This Service Information bulletin supersedes SI B61 03 15 **dated March 2015**.

SUBJECT**Various Check Control Messages Caused by Shorted K-CAN****MODEL**

F22 (2 Series Coupe)

NEW F30 (3 Series Sedan)

- A. Under driver or passenger front seat.

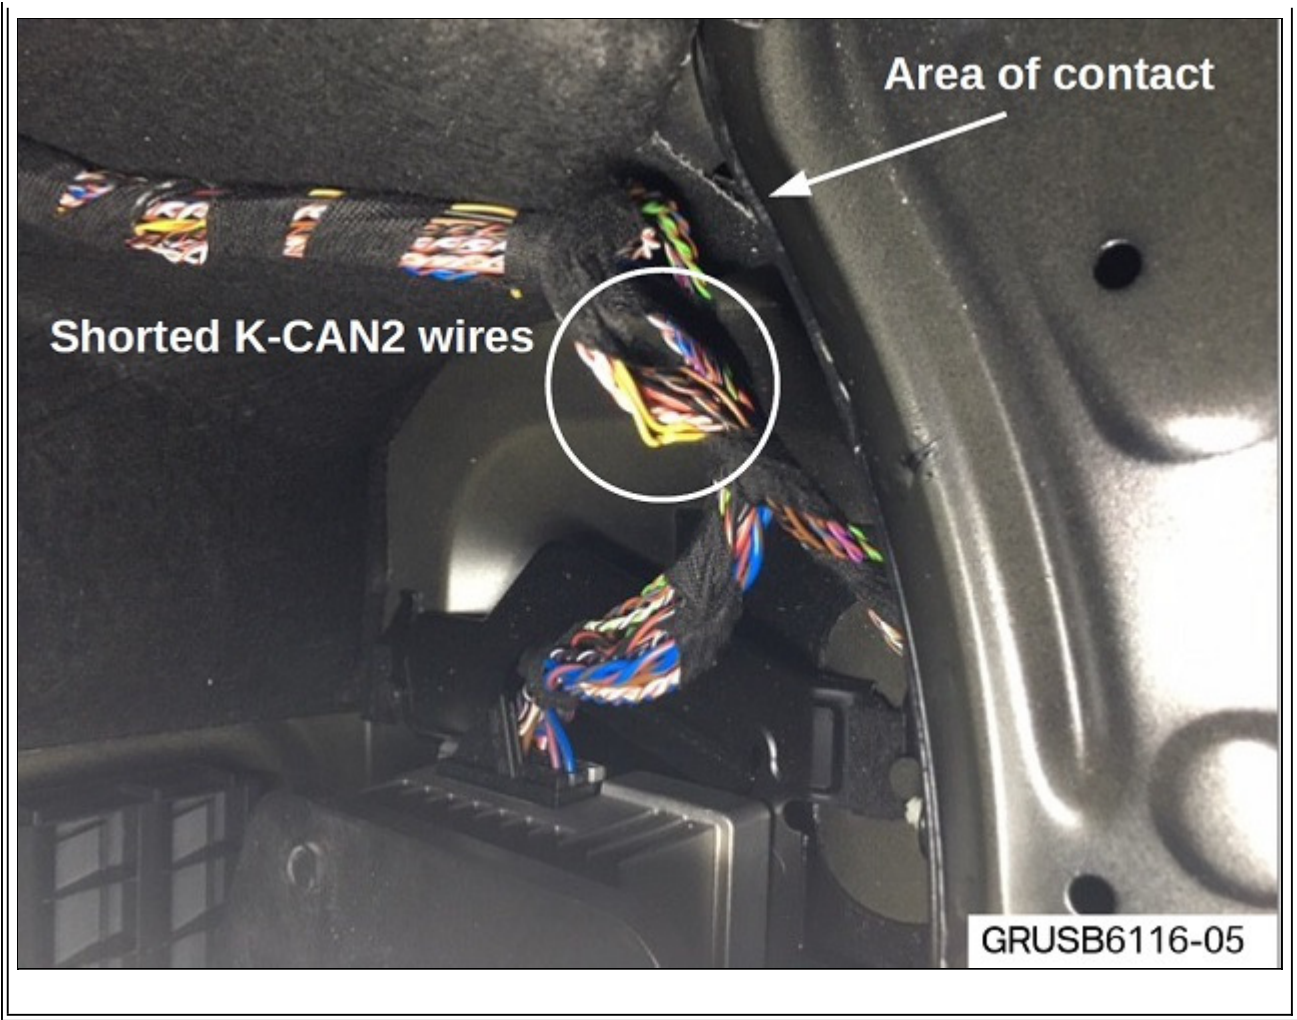
- Shorted K-CAN wiring under driver or passenger seat
- Shorted K-CAN2 wires were shorted between the left side trunk trim panel and the body of the vehicle
- Shorted K-CAN in left rear wheel well area
- Shorted K-CAN under center console trim
- Shorted K-CAN under A-Pillar trim

Repair and re-route shorted harness to prevent a repeat visit.

2. Repair short.
3. Reinstall all components, ensuring routing prevents future wire damage.
